Access Compliance Report

Public Rights-of-Way

(Curb Ramps)

Intersection ID: 3176	Main Street: OLD_TIMBER_RD	Cross Street: SUTTERS_HILL_CT	Location:	N
ADA ID: A9FDE9A9E914	Ramp Type: Perp	Initial Pass/Fail: Fail	Overall Compliance: No	Severity Score: 1.25
Codes/Mitigation Info/Possible Solution		Field Measurements/Component Compliance

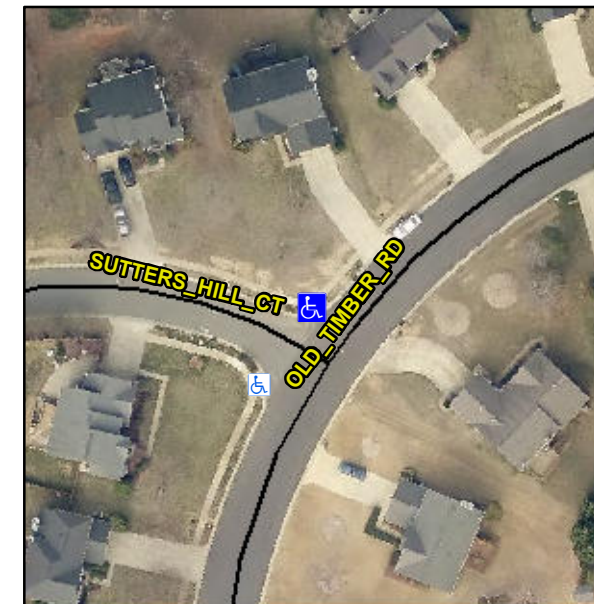
Not Found, R304.5.3

Compliance	Description	Data	Compliance	Description	Data
N/A	Ramp Length (in)	44.5	Yes	Ramp Slope (%)	6.4
Yes	Ramp Width (in)	74.0	No	Ramp XSlope (%)	4.5
N/A	Flare Type LT	N/A	N/A	Flare Type RT	N/A
N/A	Flare Slope LT (%)	N/A	N/A	Flare Slope RT (%)	N/A
N/A	Flare Traversable LT?	N/A	N/A	Flare Traversable RT?	N/A
N/A	Landing Length (in)	N/A	N/A	DWS Provided?	N/A
N/A	Landing Width (in)	N/A	N/A	DWS Contrast?	N/A
N/A	Landing Slope (%)	N/A	N/A	DWS Length (in)	N/A
N/A	Landing X Slope (%)	N/A	N/A	DWS Full Width?	N/A
N/A	Landing Curb? (Y/N)	N/A	N/A	DWS Offset (in)	N/A
N/A	Shared Landing?	N/A			
N/A	Gutter Ponding?	N/A	N/A	Gutter Slope (%)	N/A
N/A	Gutter Lip Ht (in)	N/A	N/A	Gutter X Slope (%)	N/A
N/A	Painted X Walk1?	No	N/A	Painted X Walk2?	N/A
	X Walk 1 Direction	To SW		X Walk 2 Direction	N/A
N/A	X Walk 1 Width (in)	N/A	N/A	X Walk 2 Width (in)	N/A
	X Walk 1 Slope (%)	0.7		X Walk 2 Slope (%)	N/A
	X Walk 1 X Slope (%)	1.0		X Walk 2 X Slope (%)	N/A

Remove & Replace Entire Ramp.
